## KENSINGTON & WEST KINGSFORD PRECINCT

31 December 2013

**Re: CSELR EIS submission @**

**Figure 2-8: CBD precinct existing traffic composition**

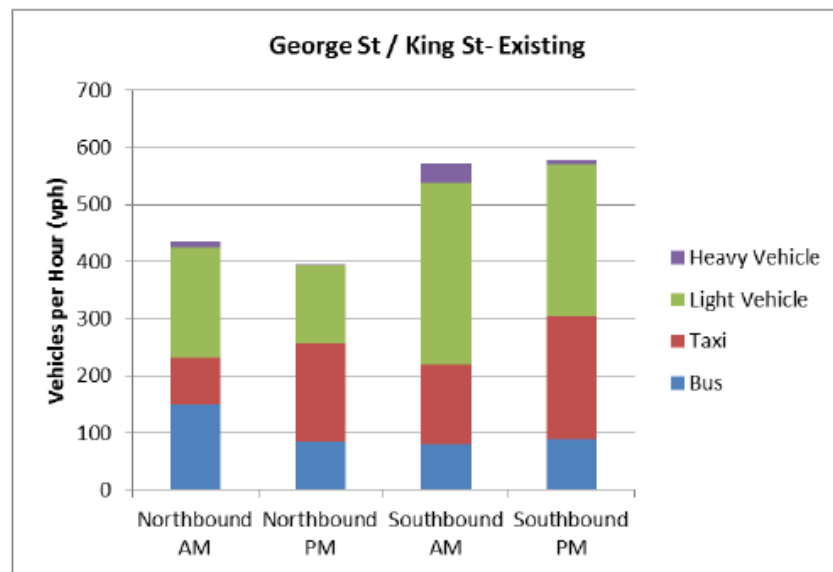
**In terms of congestion** - Volume 2 page 51 – clearly indicates that **buses comprise the LEAST component of total traffic composition** in the city AM Peak.

Volume 2 @ p51, Fig 2-8 (extracted below, next page) discloses that **greatest component causing vehicular city congestion are taxis, light vehicles (motor cars) and other heavy vehicles.** The graphs show:

- AM Peak, Northbound, buses comprise one-third or 150 of 450 vehicles per hour; and
- AM Peak, Southbound, buses comprise 80 of 570 vehicles per hour

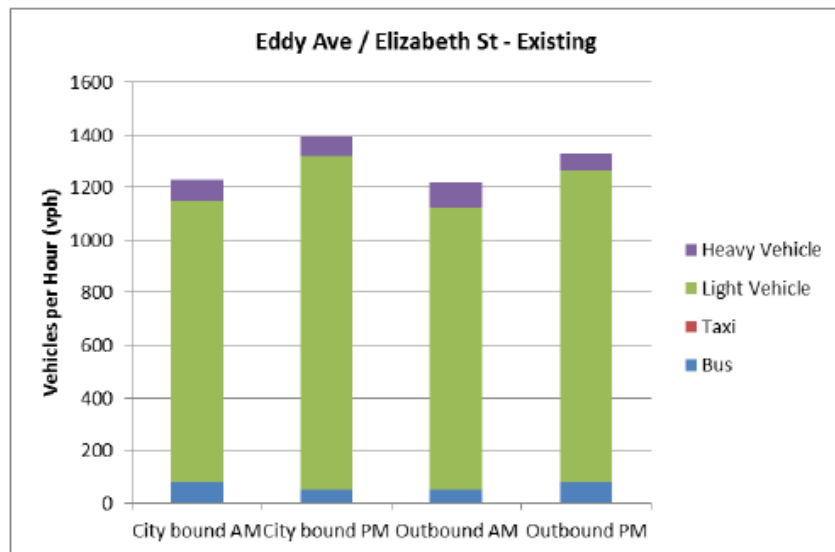
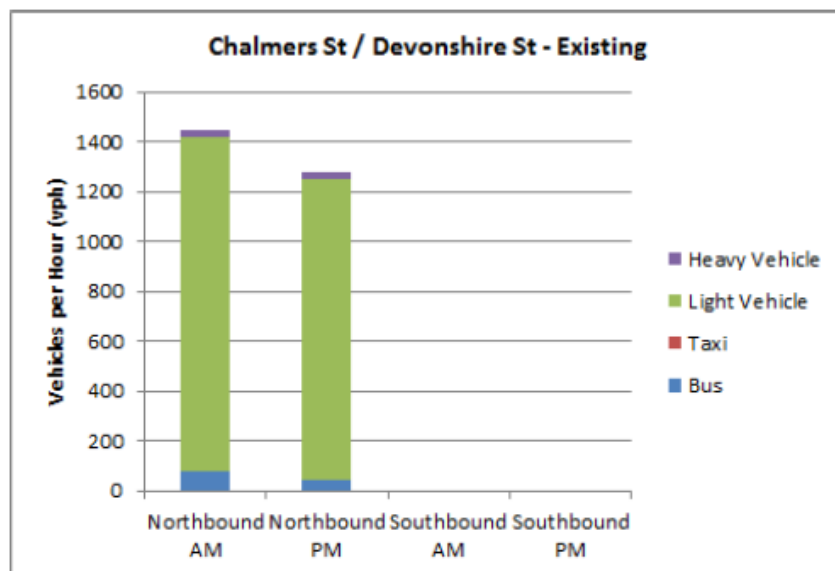
And further volume 2 page 52 – provides evidence that buses comprise the lowest component of total traffic volumes.

- The buses are described as Eddy ave/ Elizabeth st – Existing; and
- Chalmers st/ Devonshire st existing

It is abundantly clear that the greatest component of traffic volumes is comprised of motor vehicles.
